CITY OF MURFREESBORO PLANNING COMMISSION AGENDA

**MARCH 5, 2024
6:00 PM**

**MURFREESBORO PLANNING COMMISSION
STAFF COMMENTS, PAGE 1
MARCH 5, 2025
PROJECT PLANNER: BRAD BARBEE**

**MURFREESBORO PLANNING COMMISSION
STAFF COMMENTS, PAGE 1
MARCH 5, 2025
PROJECT PLANNER: RICHARD DONOVAN**

Figure 12.1

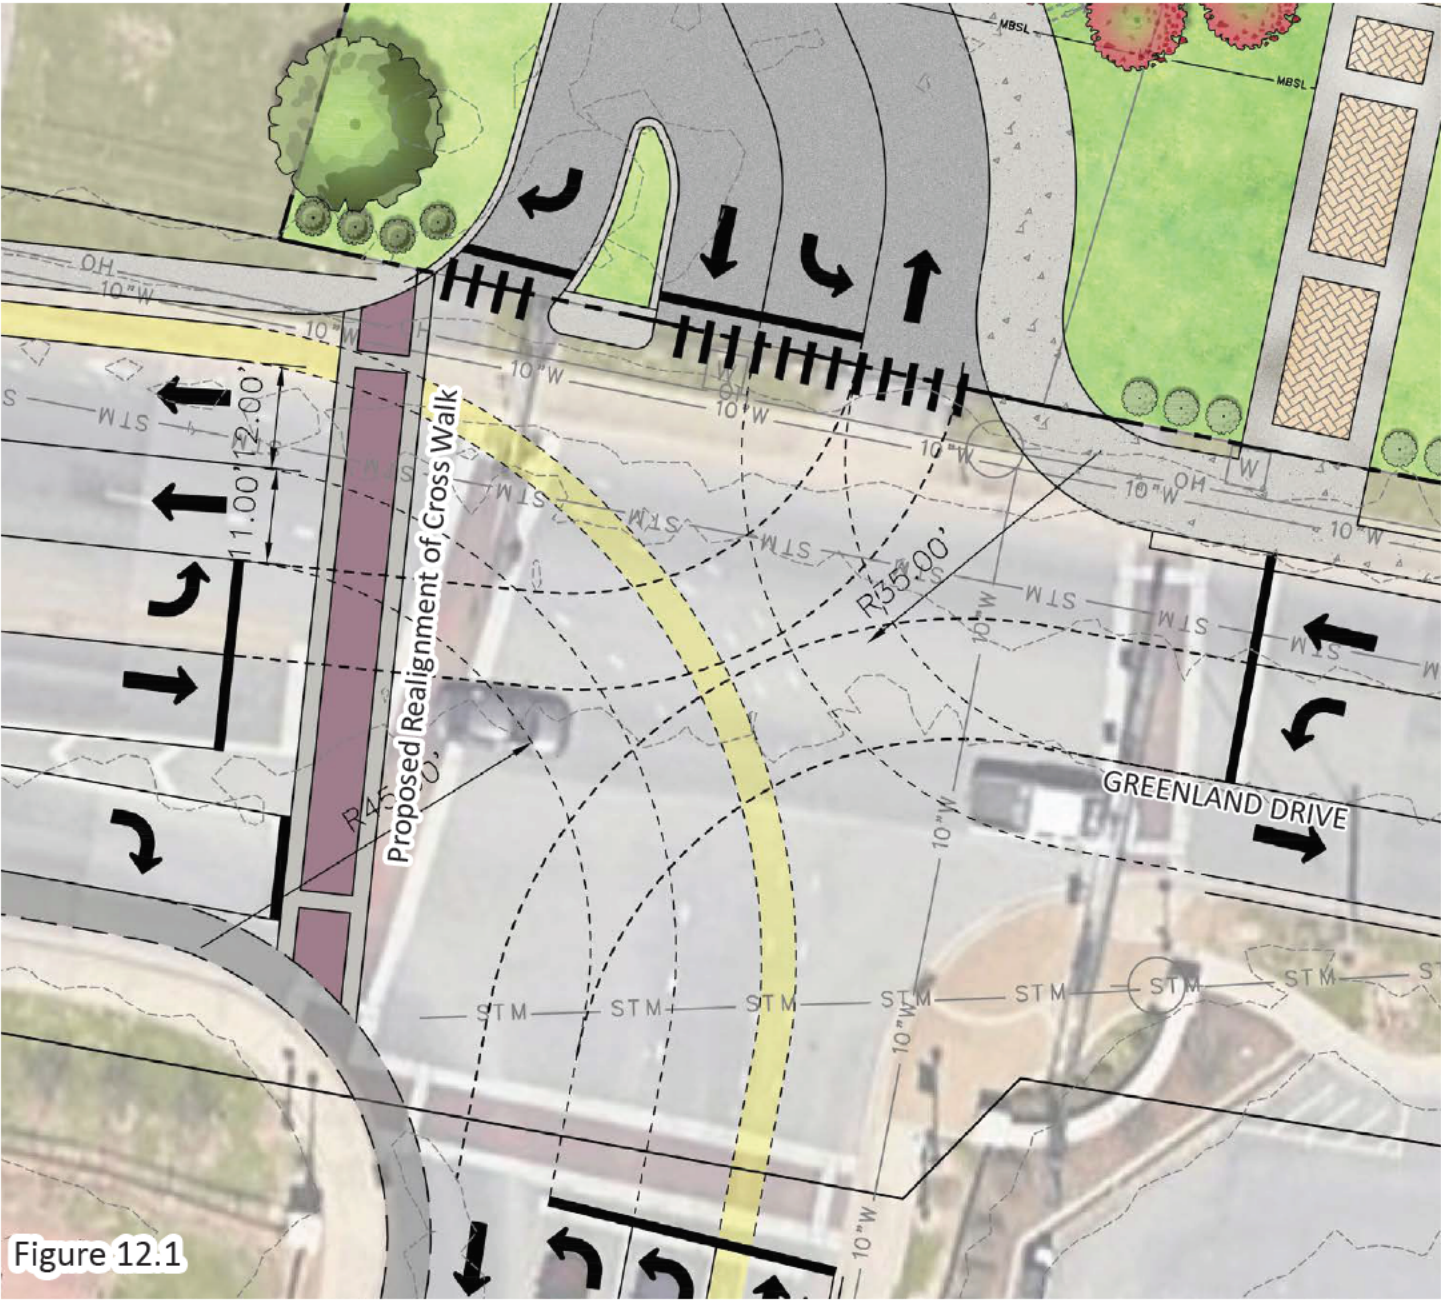
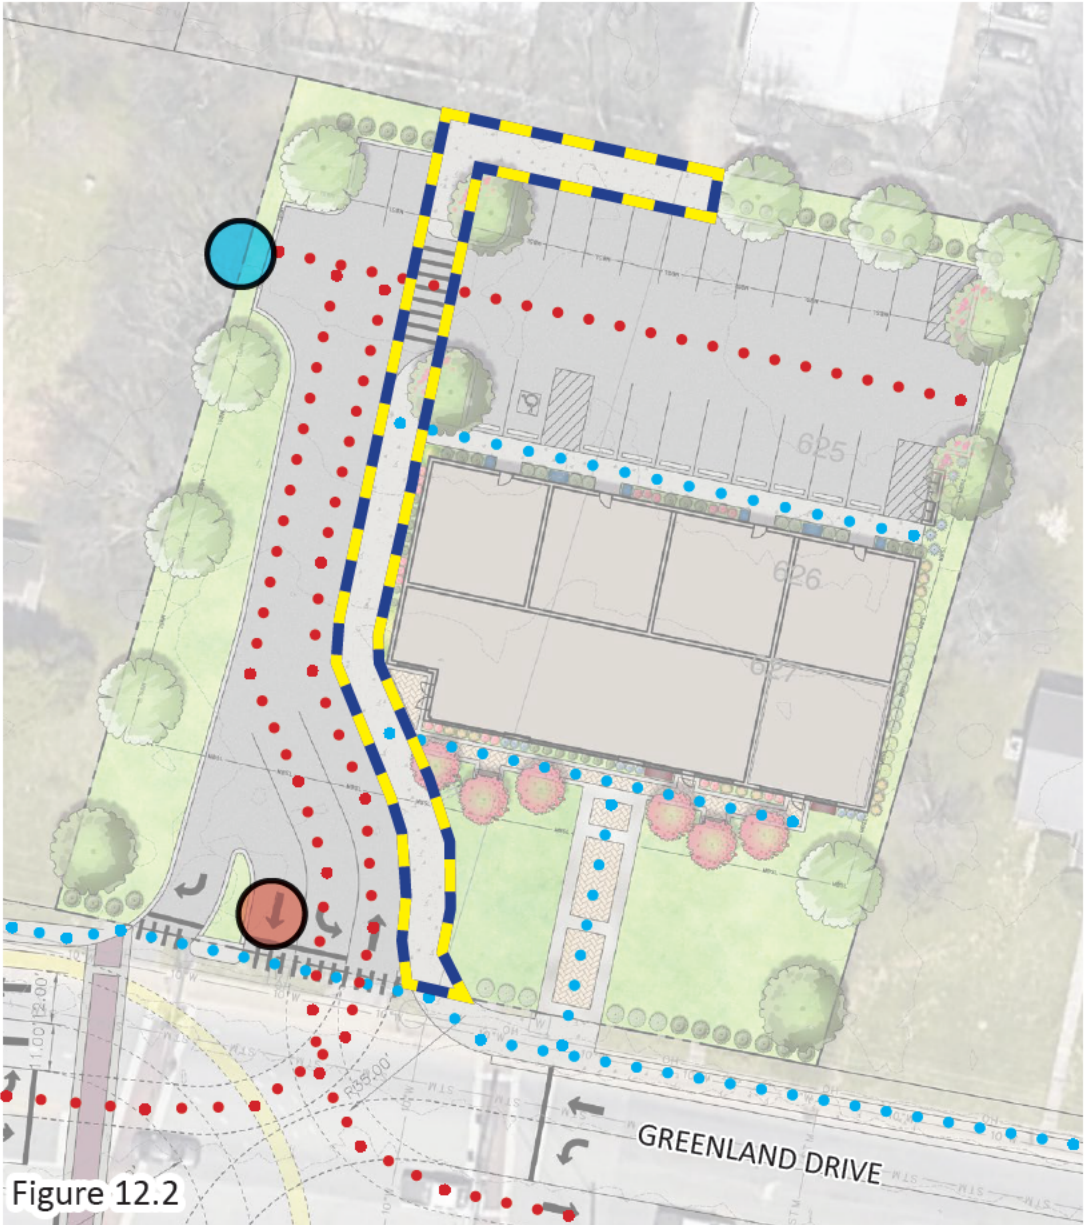
A concern was expressed regarding how a passenger vehicle could turn around without backing out into Greenland Drive if the parking lot was full. A turn template exhibit was prepared and included with the packet showing that vehicles can turn around on-site without backing into the street if all the parking stalls are in use. The site layout was adjusted to provide 2 parking spaces at the north-western corner and the trash bin enclosure area was moved further into the site and changed to trash carts serviced by a private hauler as discussed in the SEC response letter attached.

- 2) Provide a turn template showing that passenger vehicles exhibit that shows a vehicle can turn around and get back out to Greenland Drive without backing into street if all the parking stalls are in use.

Response: Added turning template (Ford F-150 w/ 8' bed). The solid waste enclosure has been revised to a trash bin enclosure. This will still be served via a private hauler. The removal of the dumpster enclosure increases visibility of the pedestrian pathway and allows the relocation of two parking spaces outside of the rear parking lot. This relocation allows the dedication of two turn-around spaces at the ends of the parking bays.
